PLANNING RESPONSES
SUNLIGHT HOUSE
APRIL 2023

EXTERNAL ALTERATIONS

INTERNAL ALTERATIONS

TYPICAL OFFICE GA

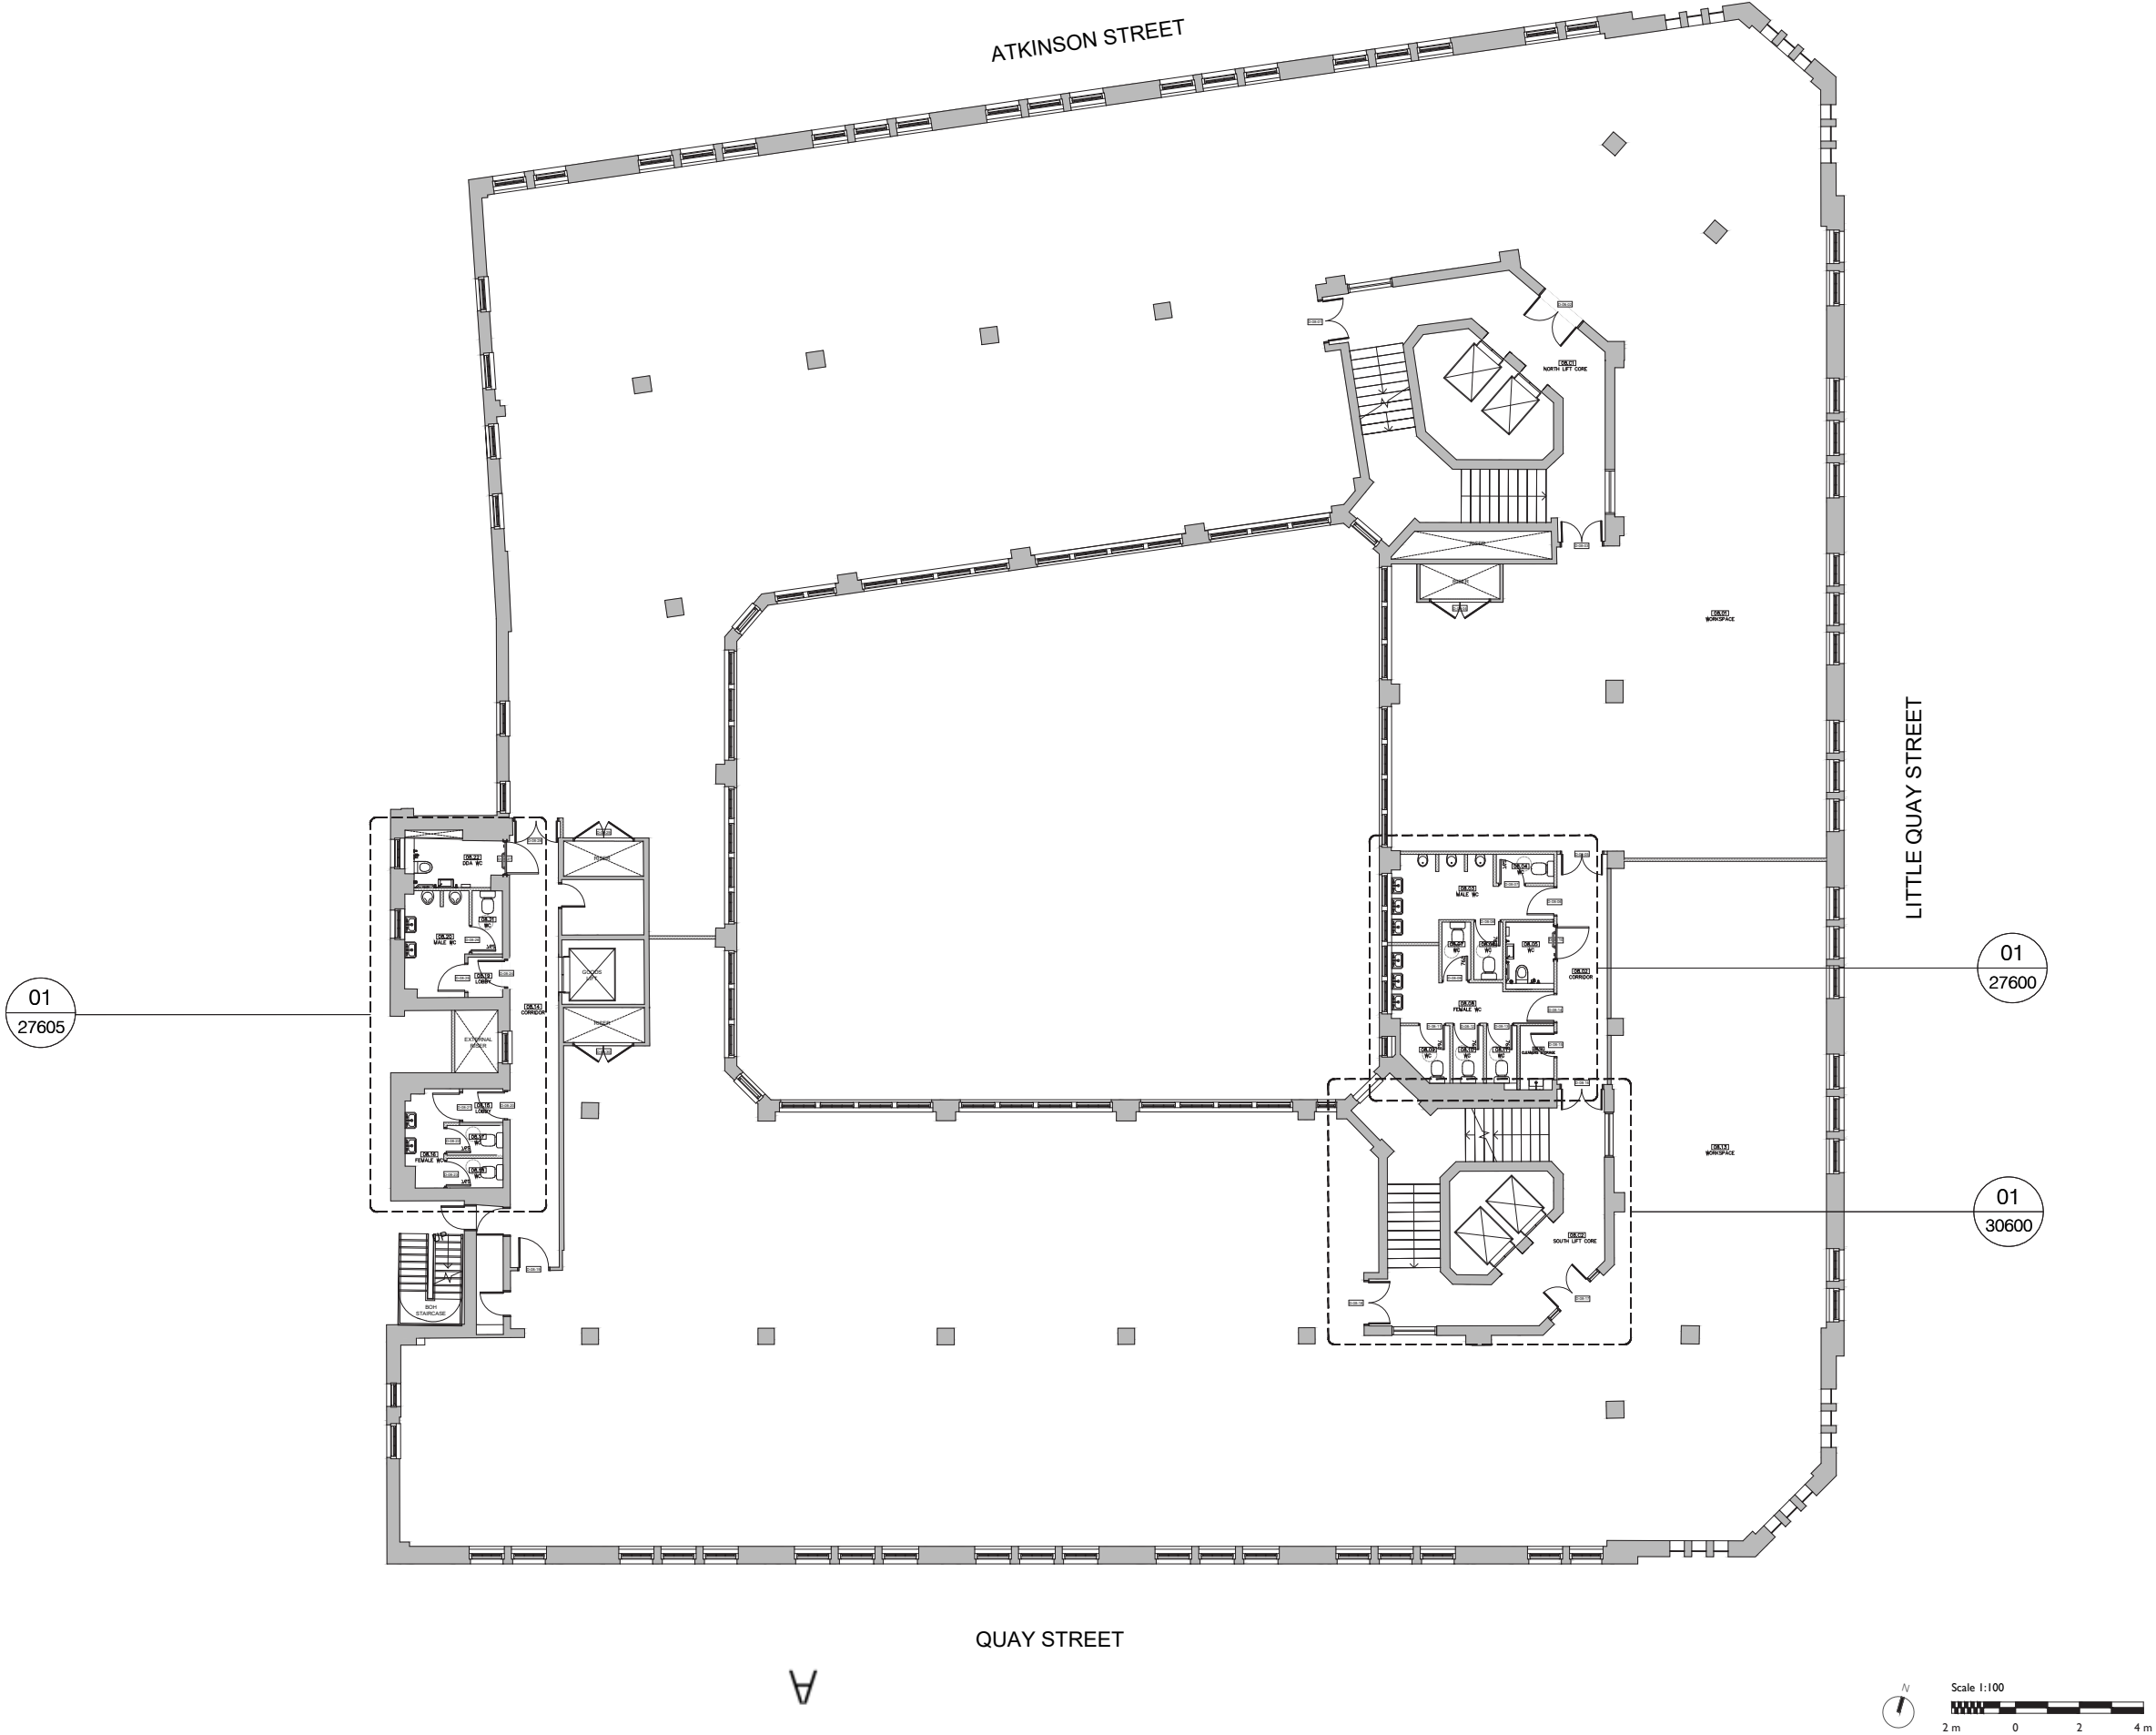
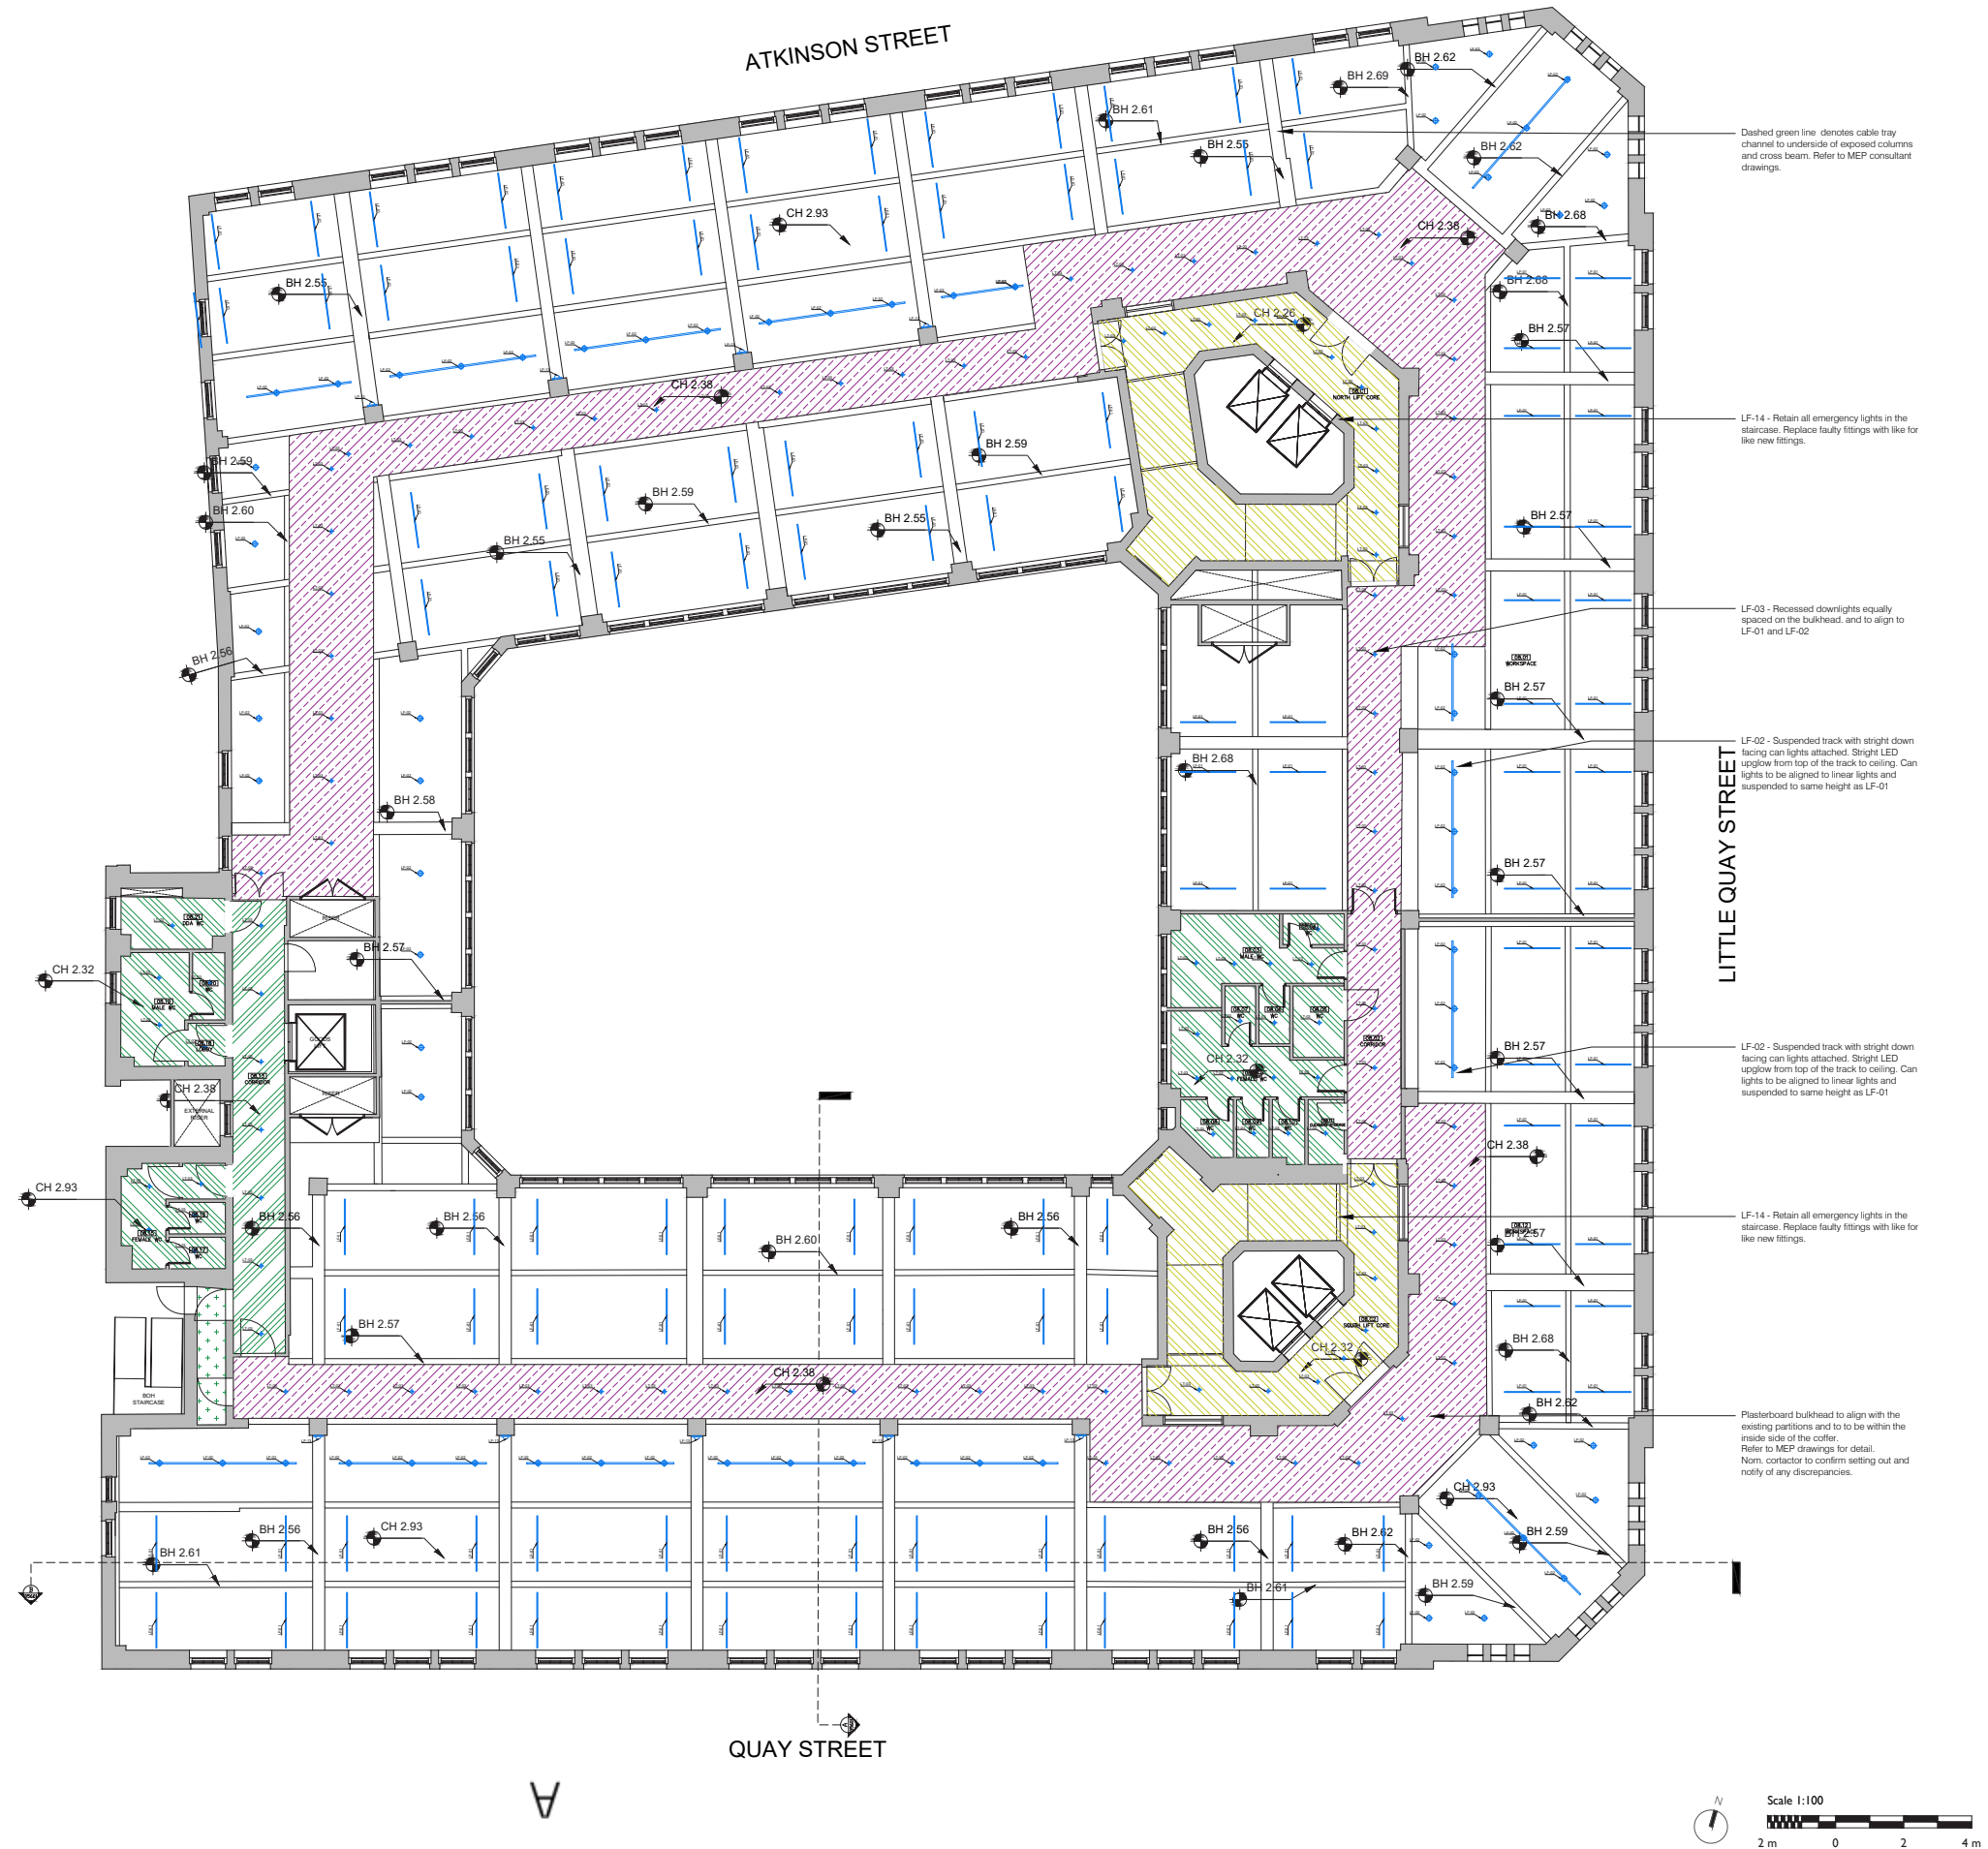
Further details of how the M&E would be routed and expressed in the internal spaces of the building needs to be submitted.

We have carefully considered the minimal amount of routing around the office space to celebrate the existing features. We are confining all significant circulation to the central bulkhead with FCU and pipework contained within the bulkehad itself. Where there are no raised access floors we are transferring power and data through trays aligned with the coffer details to perimeter trunking around the floorplate. We have sense checked this with Cat-B layouts to ensure this works in both conditions. Where raised access floor already exists on site the transfer of MEP is less of a concern.

21. RECEPTION PARTITION

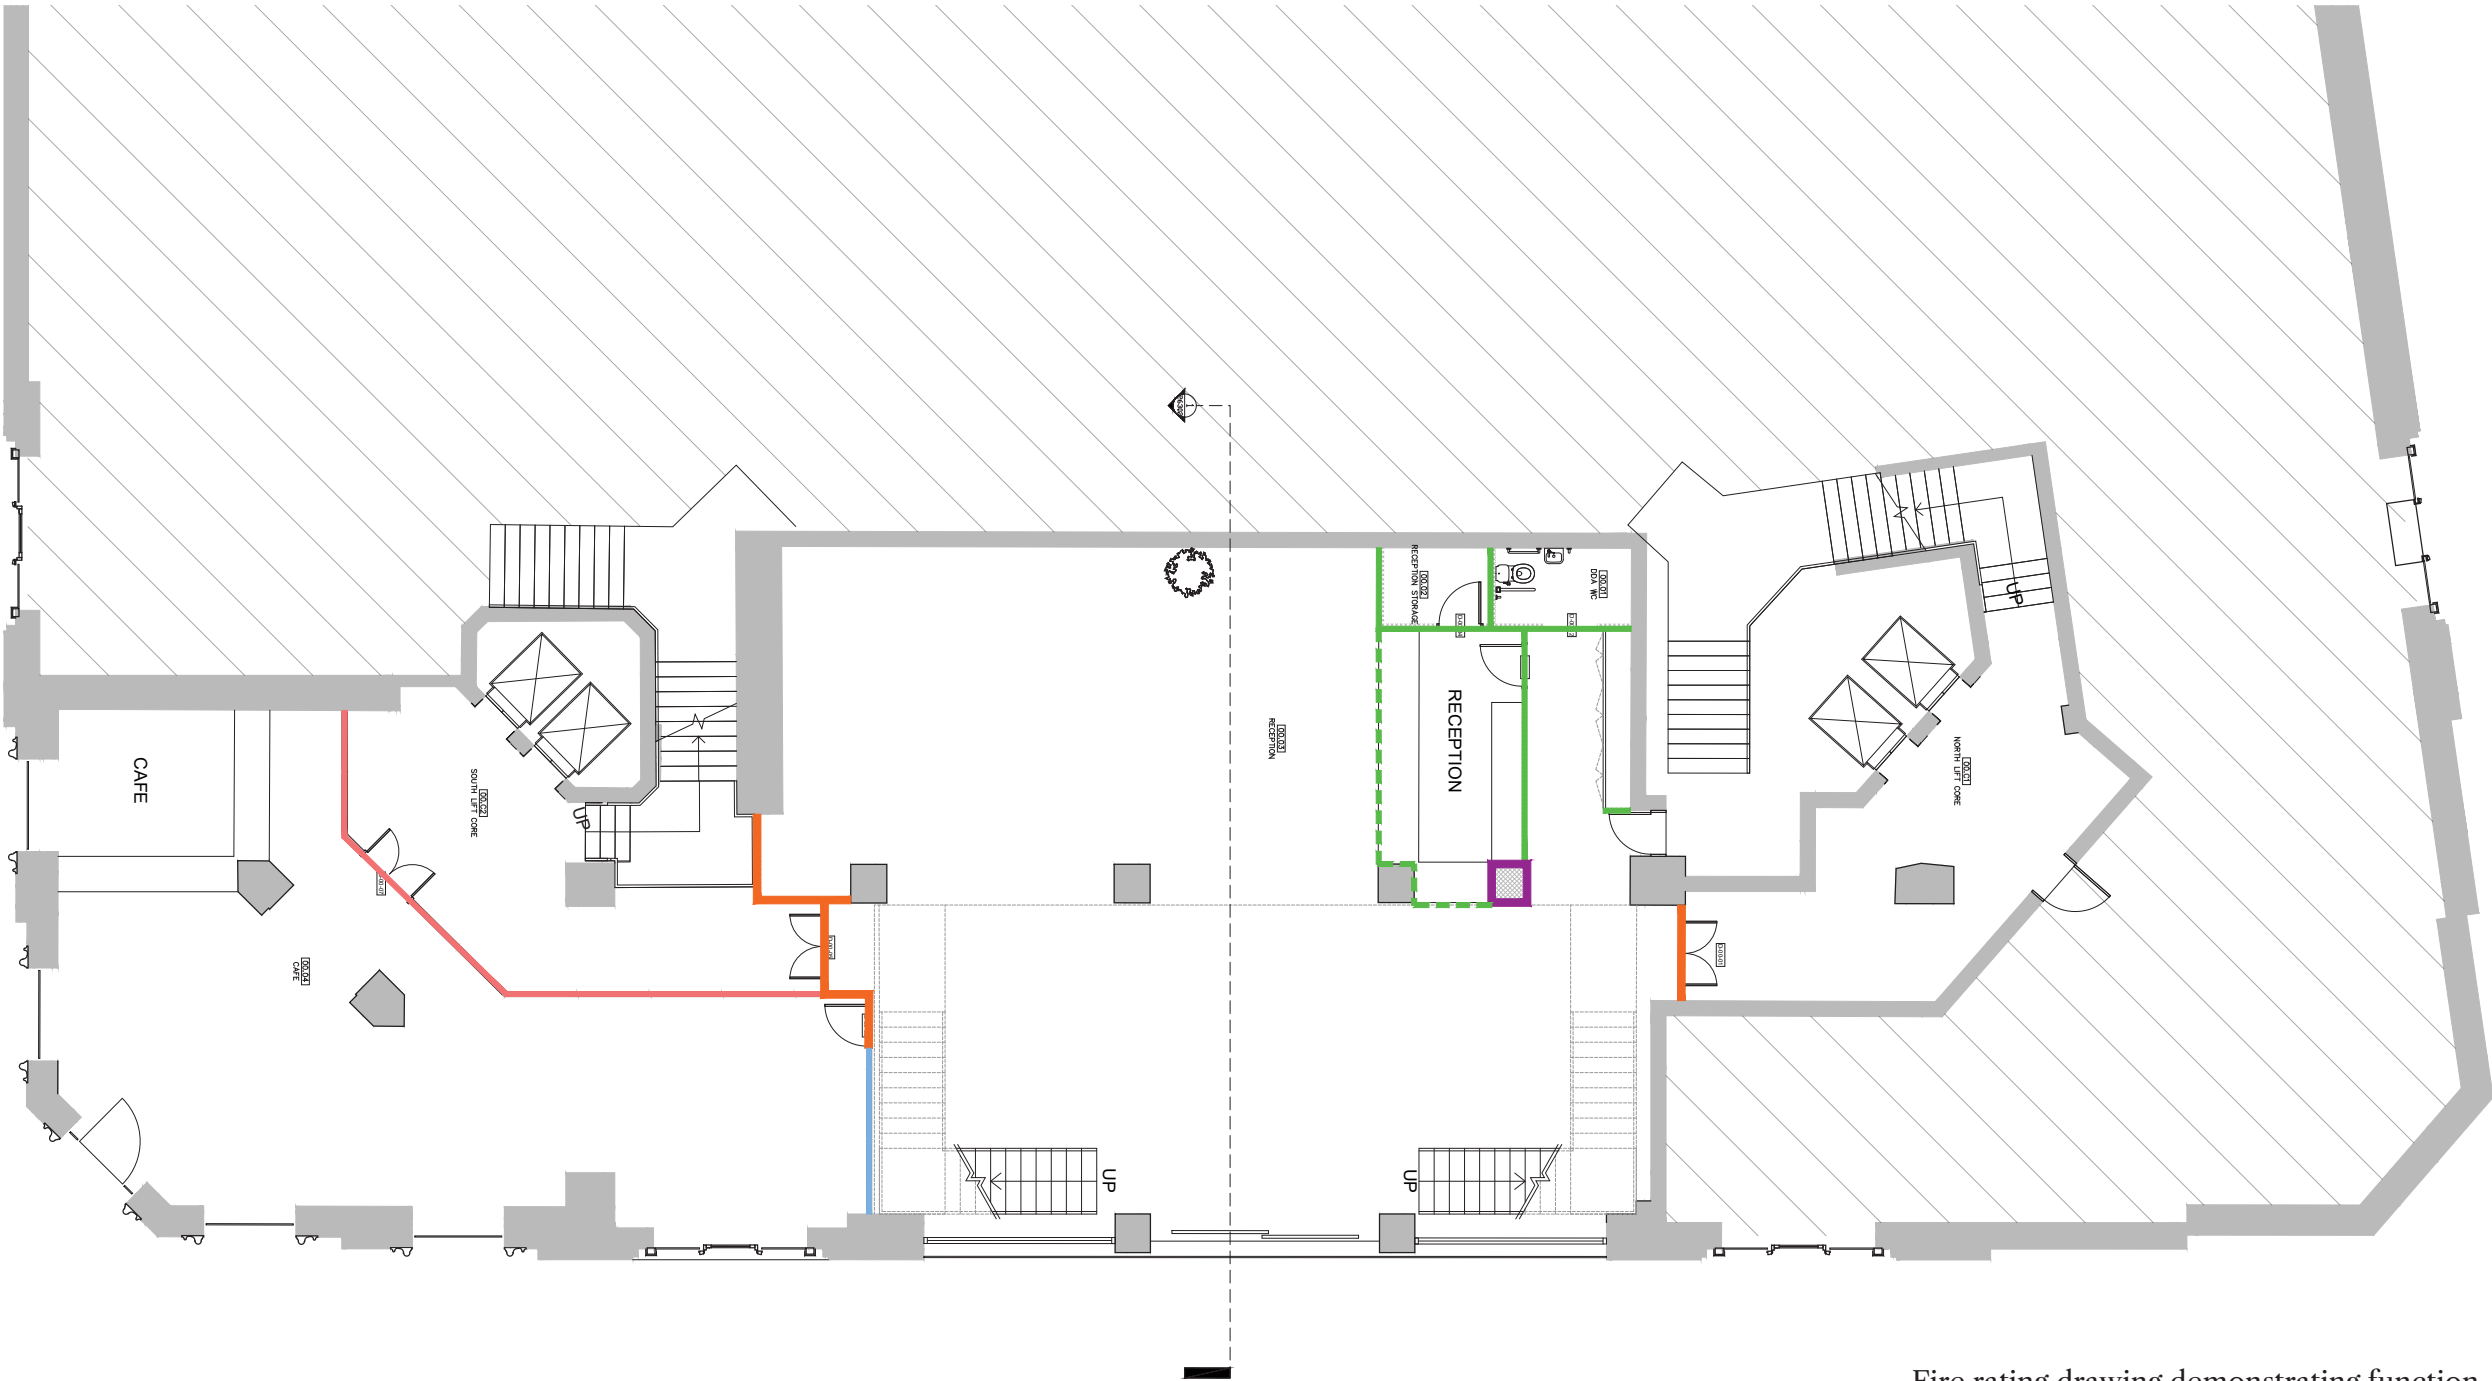
The introduction of the new partition to separate the cafe from the circulation area would detract from the stone archway and affect the openness of the space. The partition appears to cut crudely across the existing ceiling features. Can we look at this on our site visit?

The rear partition is introduced for two primary reasons:

- 1. It acts in place of the fire curtains within the reception space to divide the staircase exit and the proposed cafe unit
- 2. As a secure line between the two demises.

Fire rating drawing demonstrating function of wall and pocket doors in similar way to the north-eastern corner of the building.
